HOMES NSW

29 FLORIDA STREET  
SYLVANIA (SSD-83258708)

RESPONSE TO SUBMISSIONS

REVISION 04

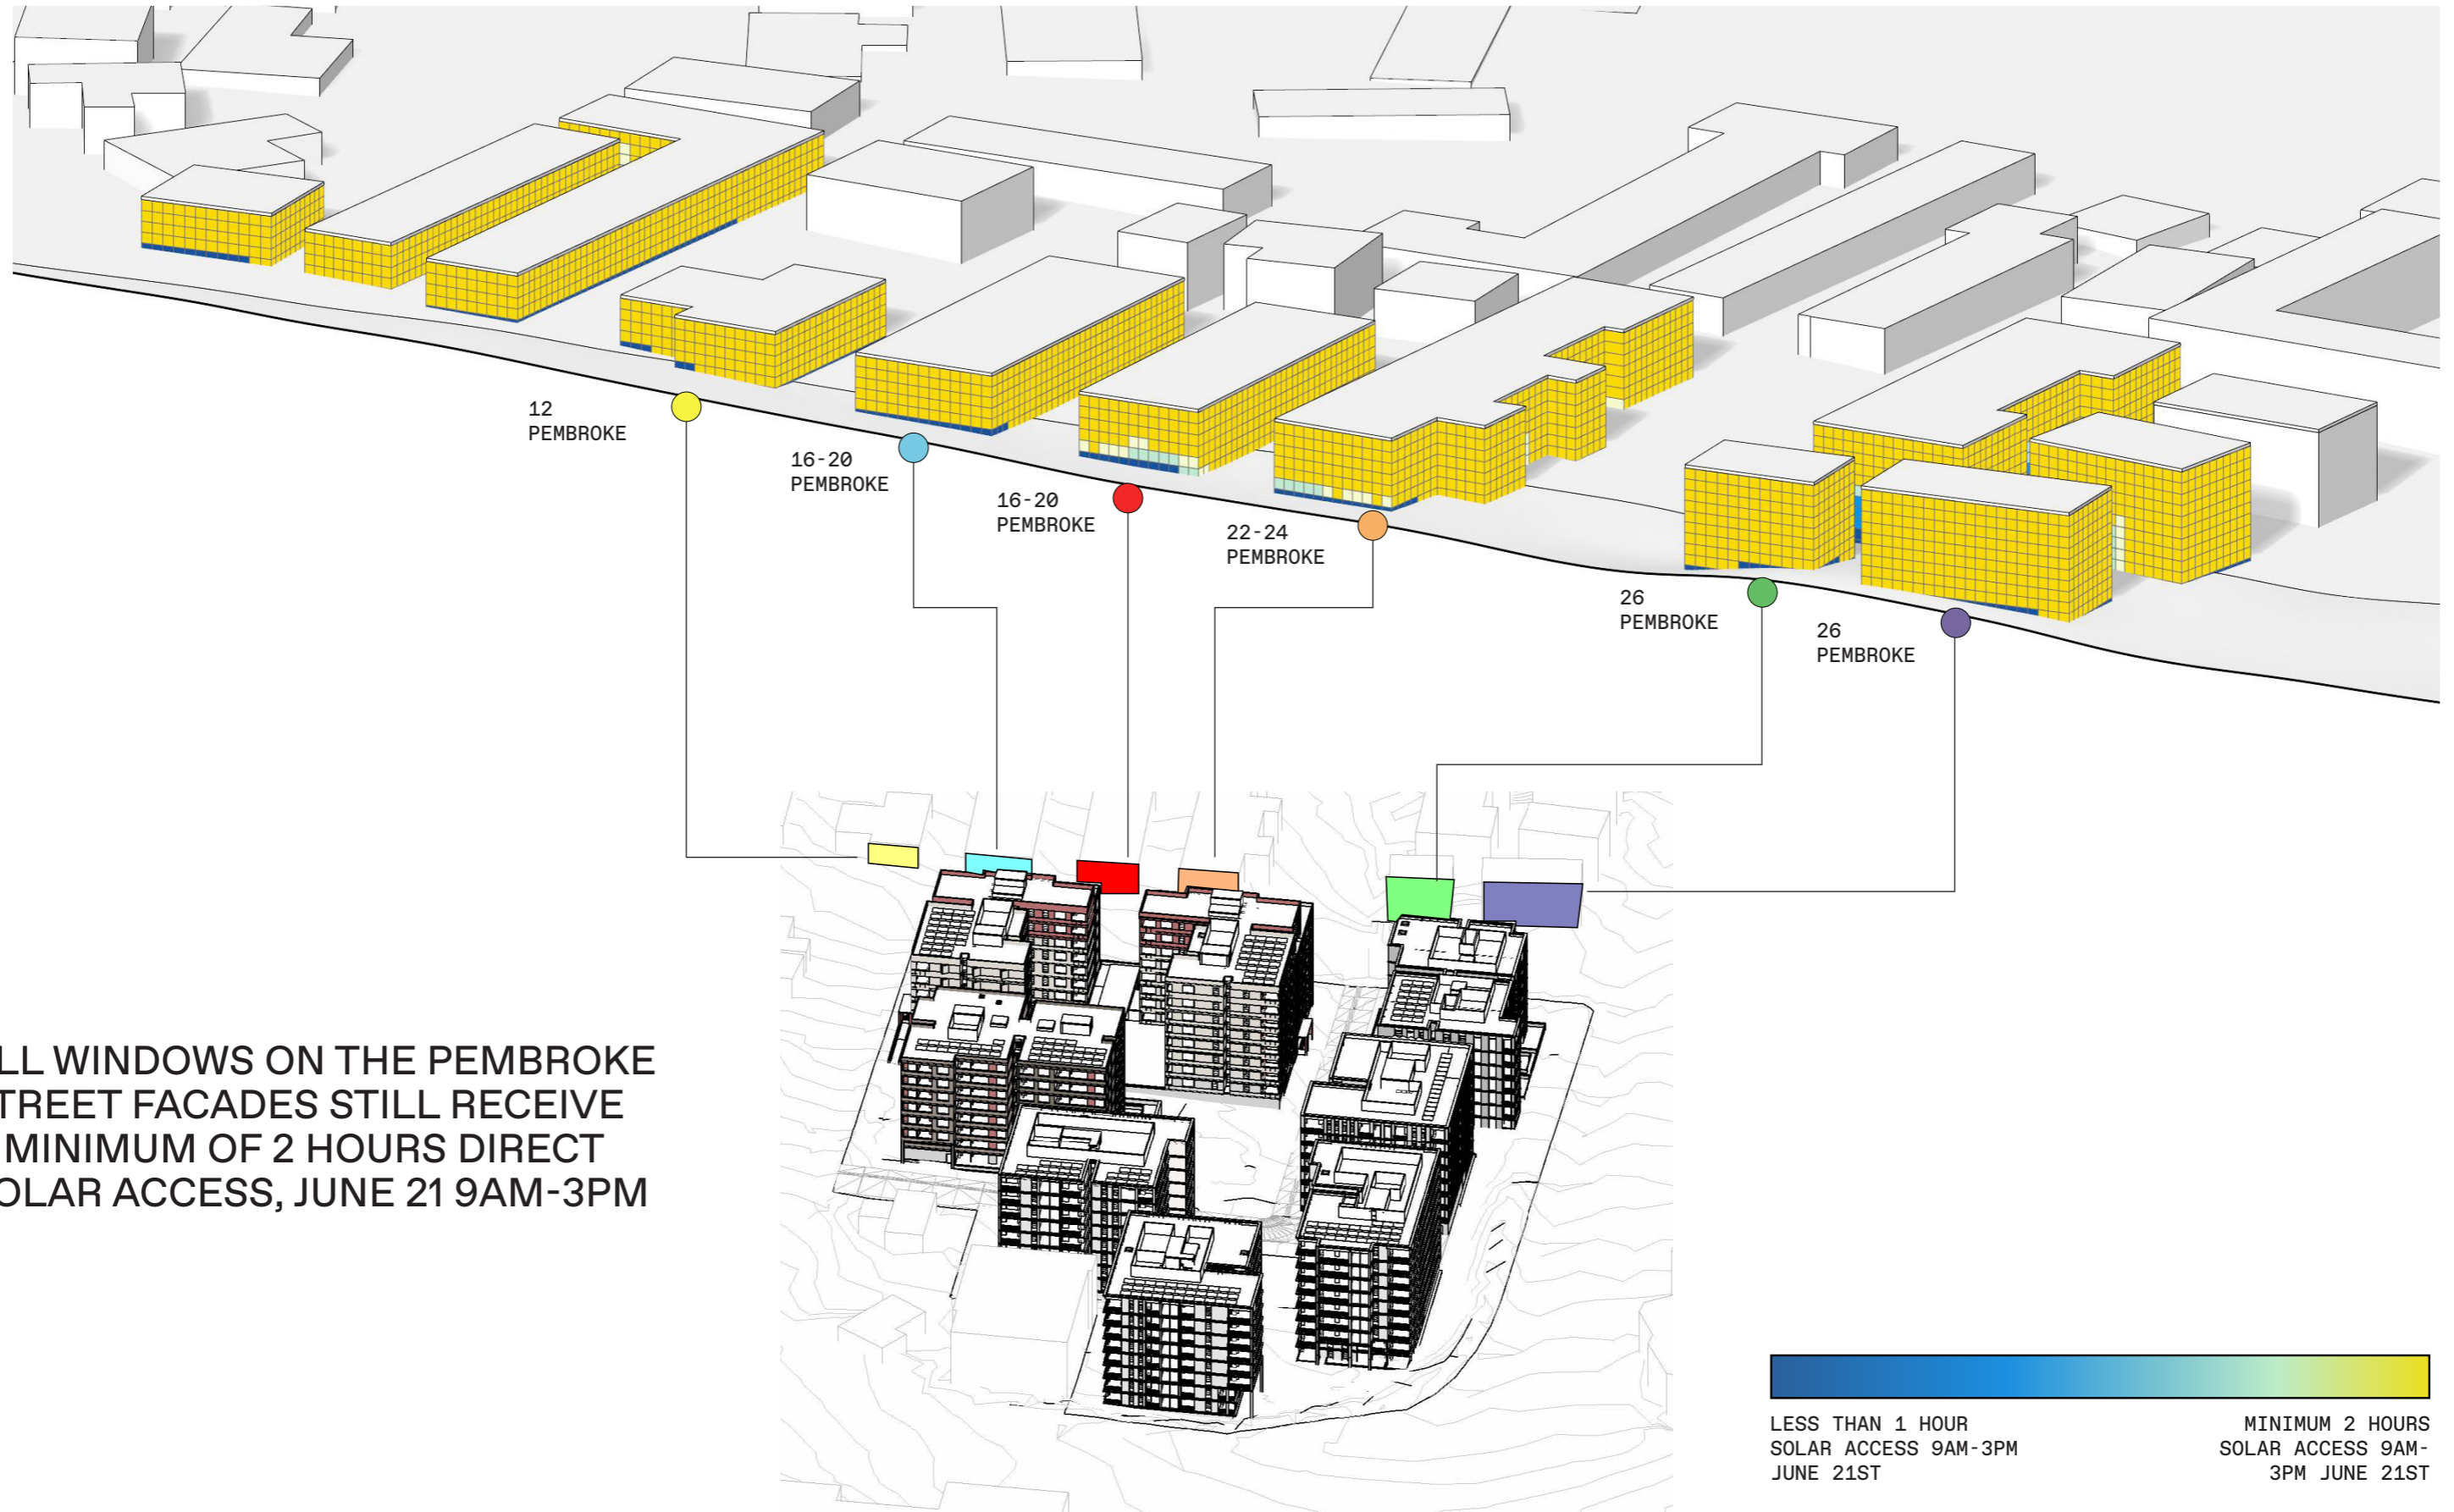
NO.	ISSUE RAISED	RESPONSE
<b>BUILT FORM &amp; URBAN DESIGN</b>		
4.1	<p>There are inconsistencies between the solar access diagram and sun-eye views plan making it difficult to accurately assess the extent of overshadowing generated by the proposed height exceedance on adjoining residential buildings on the southern side of Pembroke Road (i.e., 16 to 26 Pembroke Street).</p> <p>Please review and clarify the extent to which the proposed height exceedance contributes to overshadowing generated by the proposal.</p>	<p>The solar access diagram provided in the Architectural Design Report reflects the portions of facades of the properties along Pembroke Street that receive a minimum of 2 hours of direct sun between the hours of 9am - 3pm on June 21. This does not suggest that the development does not result in any additional overshadowing from current conditions, only that the required solar access to these sites based on ADG minimums is achieved. It is therefore not an assessment of the extent to which the height exceedance contributes to overshadowing of the neighbouring properties.</p> <p>The analysis has been undertaken based on information available to the design team at the time of submission - this included an extrapolated model of neighbouring buildings and topography based on ELVIS spatial data. The parametric analysis measures the facade based on a 1mx1m grid, at each 15 minute increment, it is therefore more granular and nuanced than the sun eye view studies which are not provided at such a fine increment and time period.</p> <p>To provide greater clarity, diagrams on the following page highlight each of the individual facades to give a clearer correlation between what is receiving sun at each time increment and associates this with the analysis provided in the report.</p>

The following diagram is a sectional view along Pembroke Street reflecting the extent of facade receiving 2 hours of direct solar access. This is measured with a 1x1m grid across the entire facade plane of the building.

HOURS OF DIRECT SOLAR ACCESS 9AM-3PM JUNE 21ST

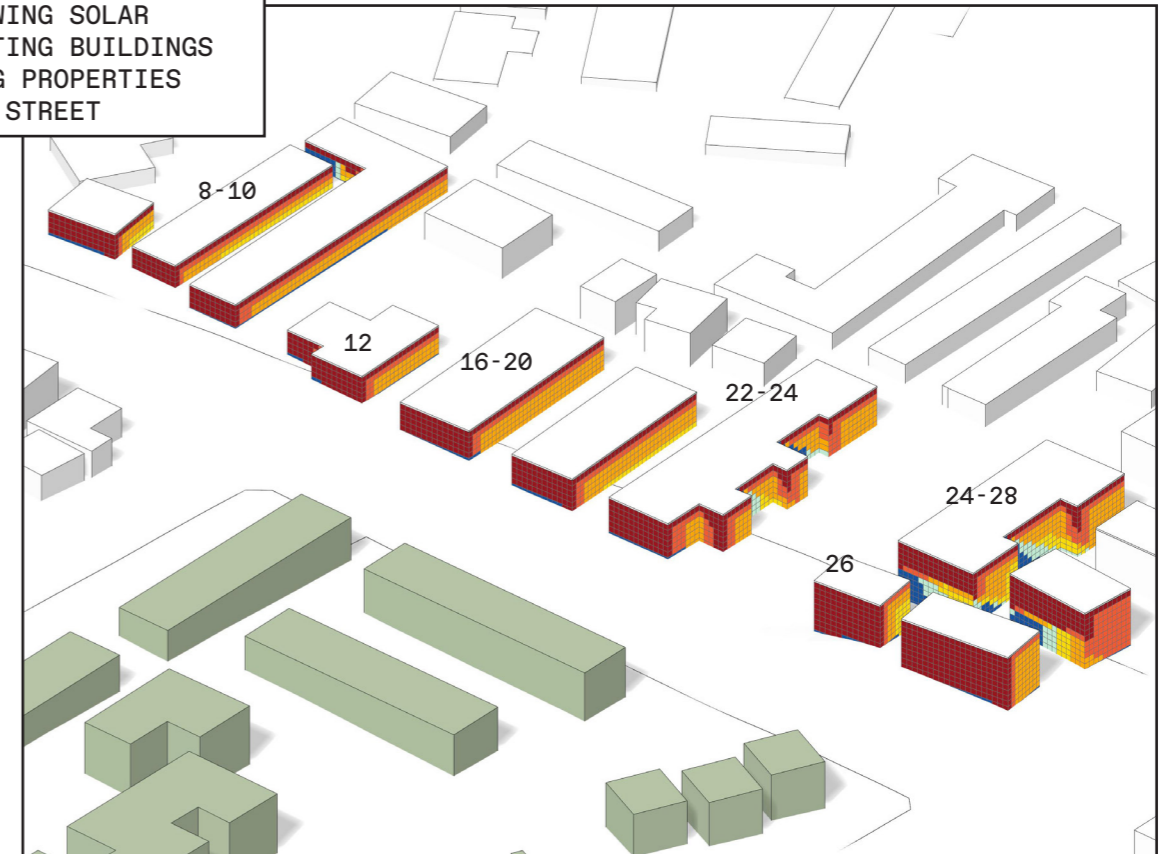
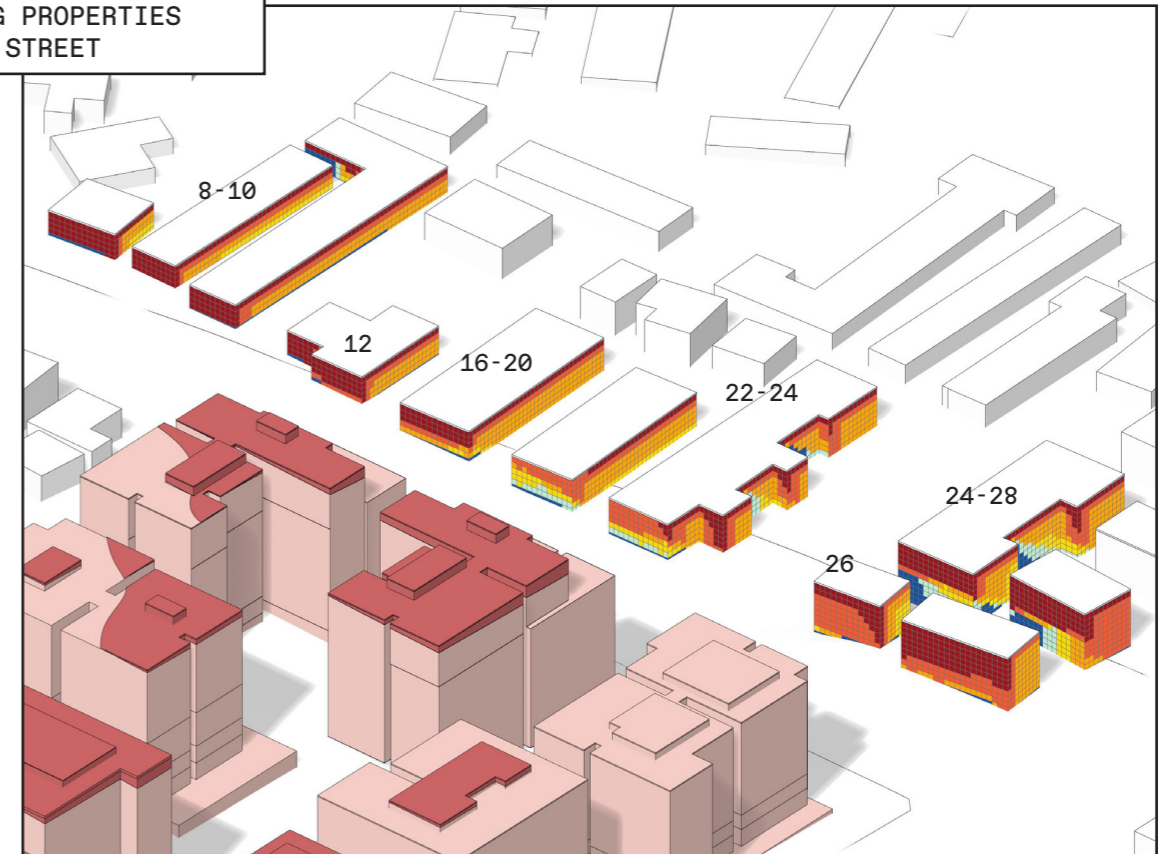
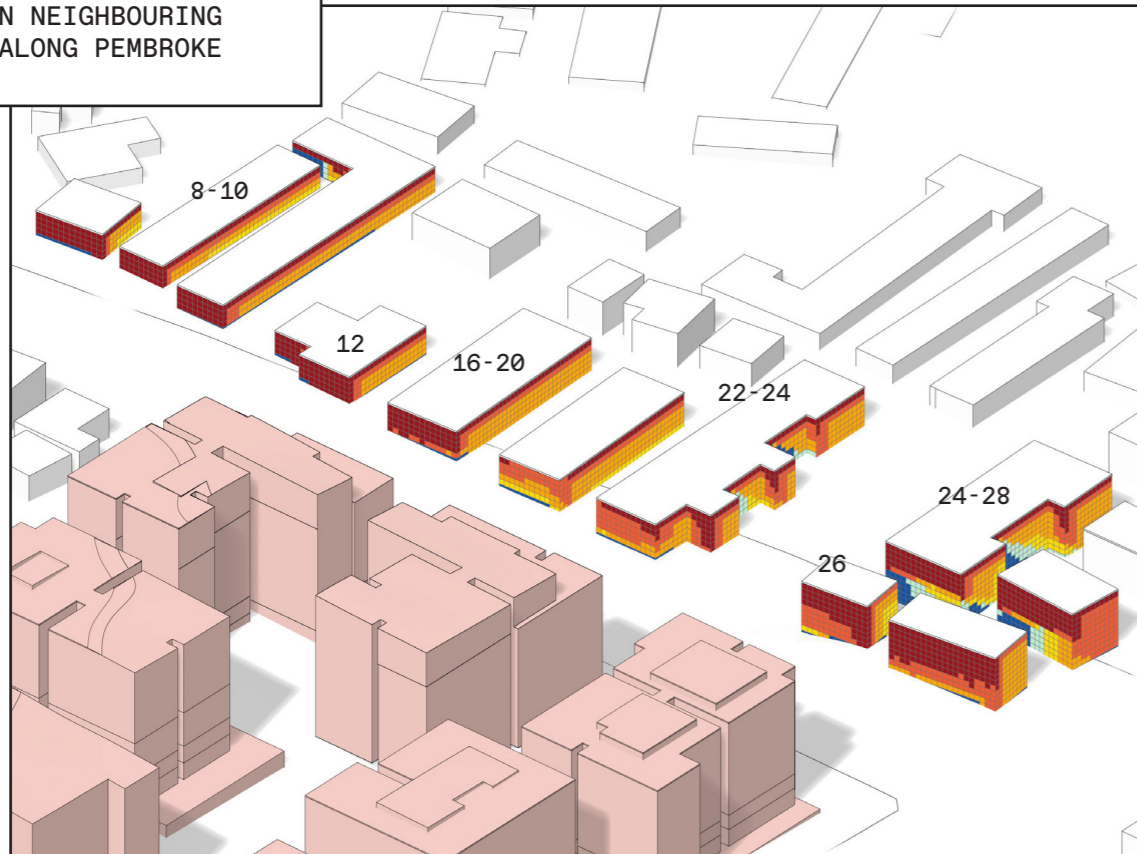
To more comprehensively understand the overshadowing impact of the proposed development and one with a compliant height of 28.6m, a broader analysis of solar access to facades along Pembroke Street has been undertaken. The diagrams below assess the extent of facade that has access to up to of 5 hour of sun on June 21 9am - 3pm.

Diagram 1 indicates that the majority of facades receive 5 hours of direct solar access along Pembroke Street, which is reduced to generally 2-3 hours where the buildings overshadow themselves on their northern facades.

Diagram 2 shows that a height compliant scheme has some impact on these results, particularly for the buildings at 16-20 Pembroke Street and 22-24 Pembroke. However, generally these facades are still receiving a minimum or 2 hours of sun. There is a minor impact in solar access to the buildings at 26 Pembroke Street at the corner of Pembroke and Port Hacking. These facades go from a minimum of 5 hours of direct solar access, to receiving 4-5 hours.

Diagram 3 illustrates a very minor increase impact to the facades of the buildings at 16-20 Pembroke and 22-24 Pembroke Street where the proposed massing exceeds the maximum permissible height. While these facades have a minor reduction in solar access, this occurs only at lower levels where solar access goes from 2 hours, to between 0-2 hours. The upper areas of the facade remain generally unaffected and still receive updates for 3 hours of solar access

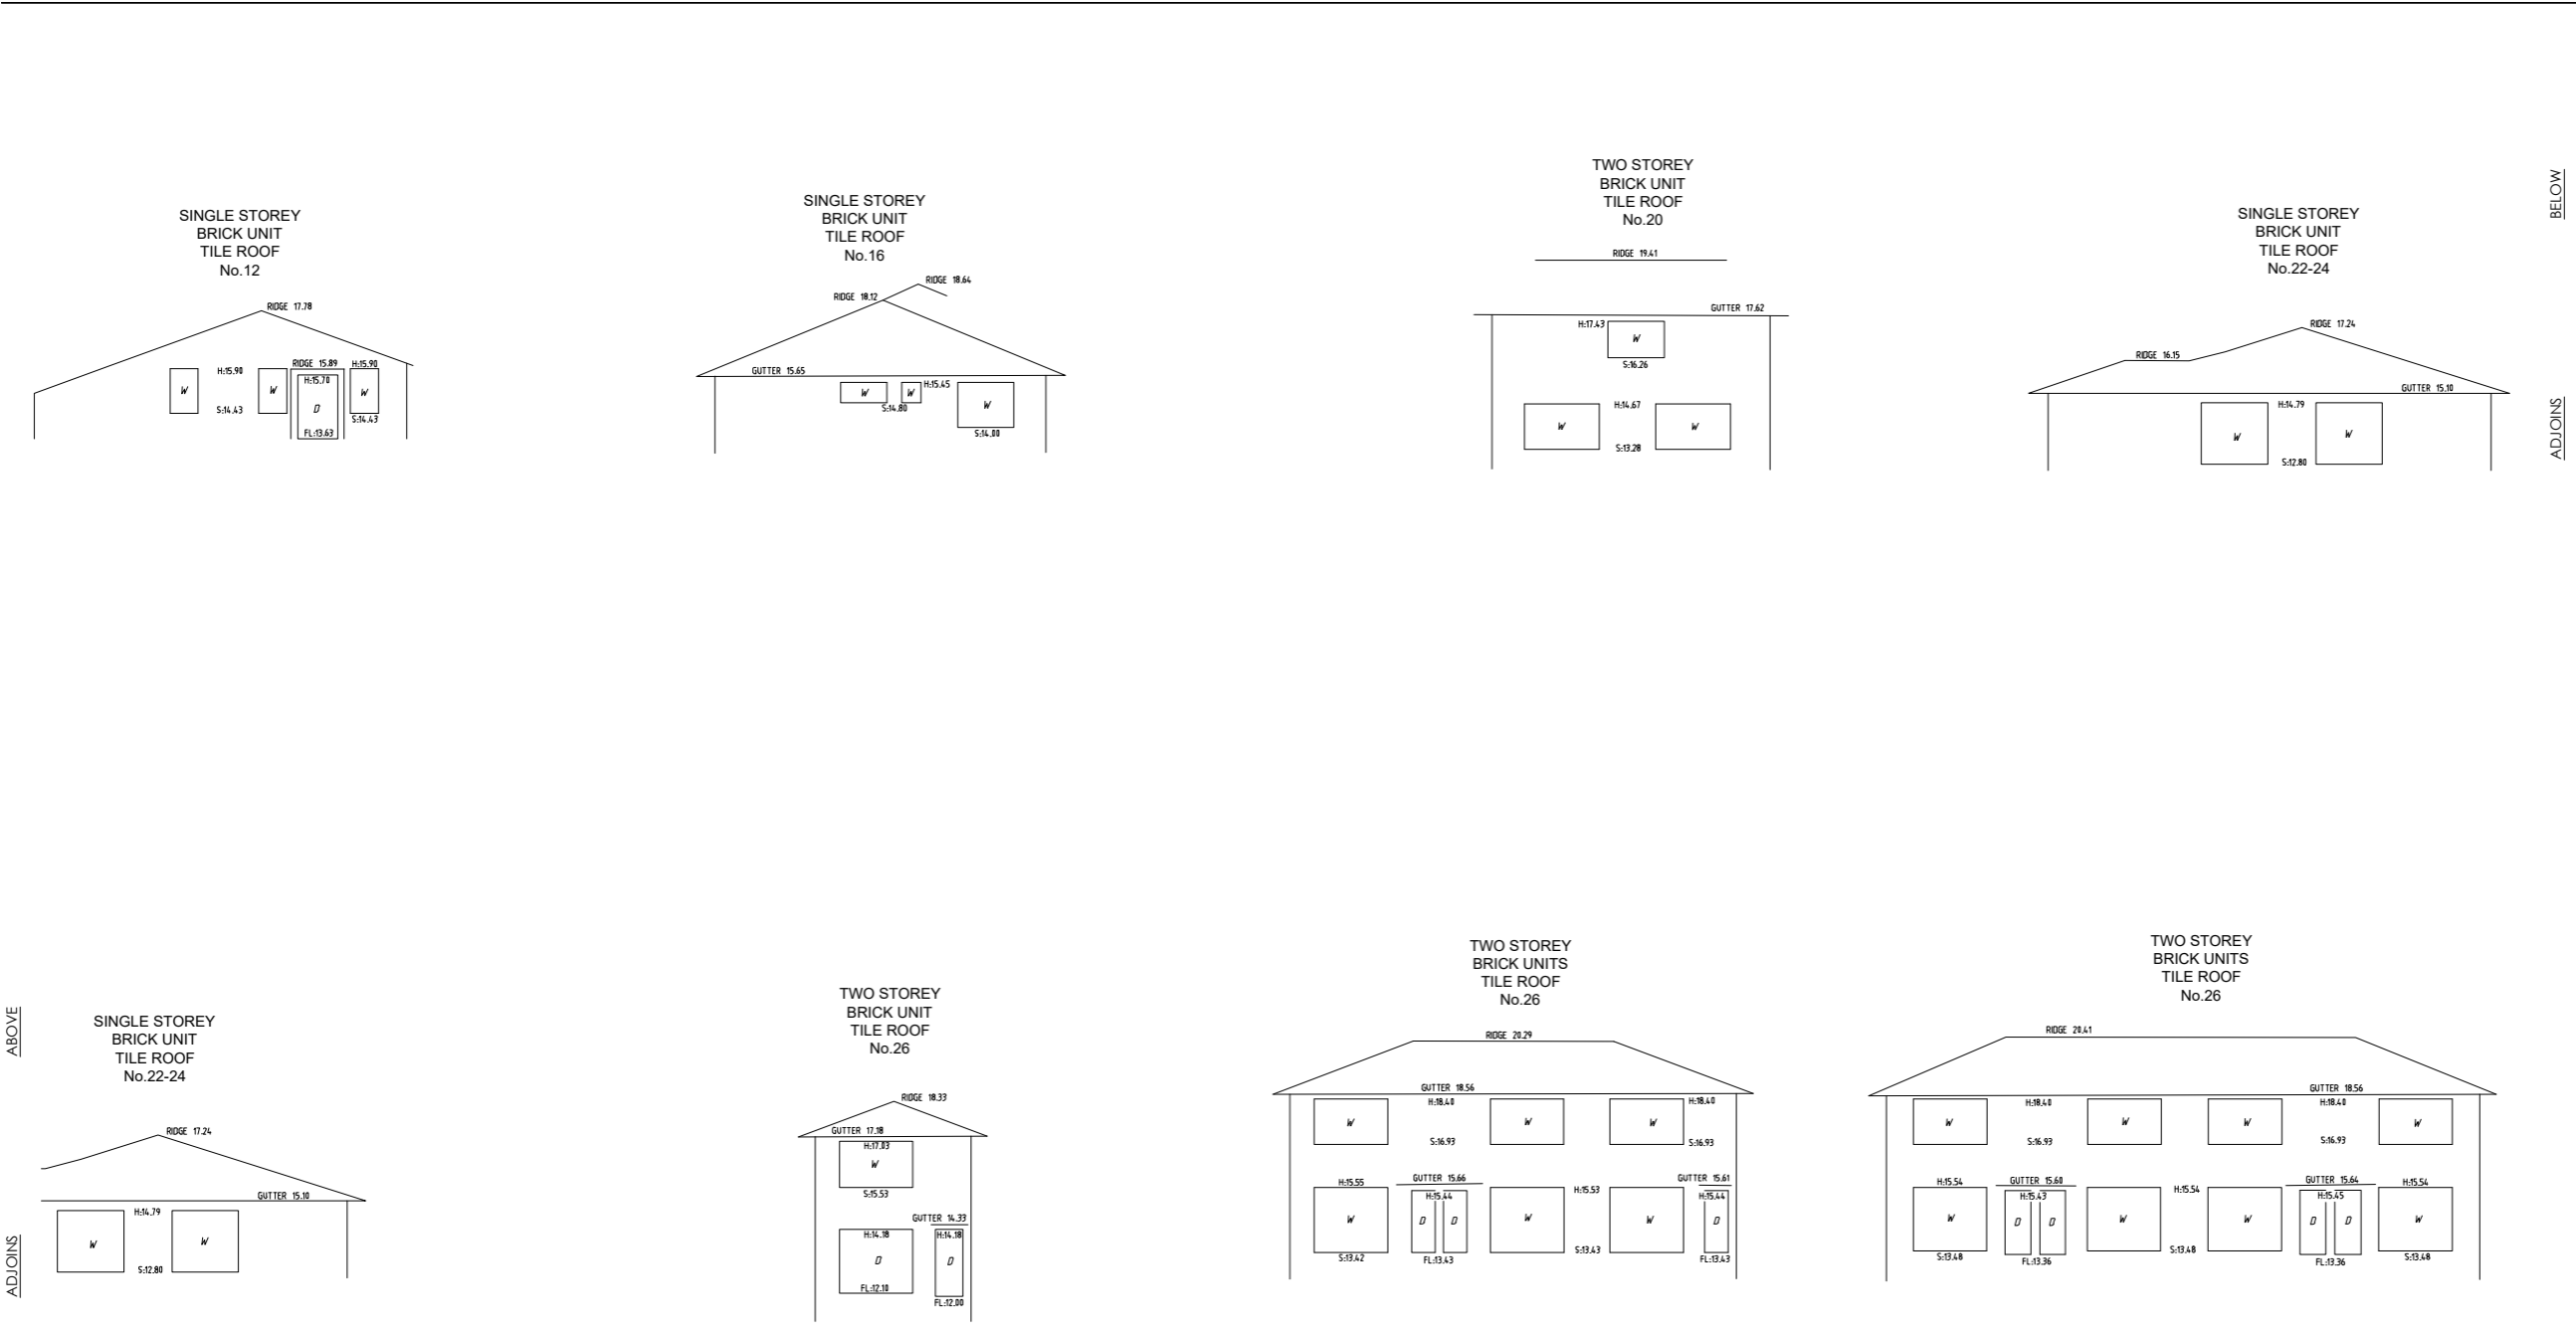
NO.	ISSUE RAISED	RESPONSE
BUILT FORM & URBAN DESIGN		
4.2	Provide modelling of the adjoining Pembroke Road residential buildings impacted by overshadowing, identifying areas of private open space and windows to habitable rooms, and quantify the duration and extent of overshadowing resulting from the proposal	Some survey information has been made available to the design team following the submission of the SSDA as reflected below however, internal layouts and details around private open spaces have not been obtained at this stage. The analysis undertaken in response to item 4.1 indicates the impact to the Pembroke Street facades holistically which is further described below. Preliminary desktop analysis suggests that private open spaces to these dwellings occur along their north and south facades, therefore, those fronting Pembroke Street are secondary.
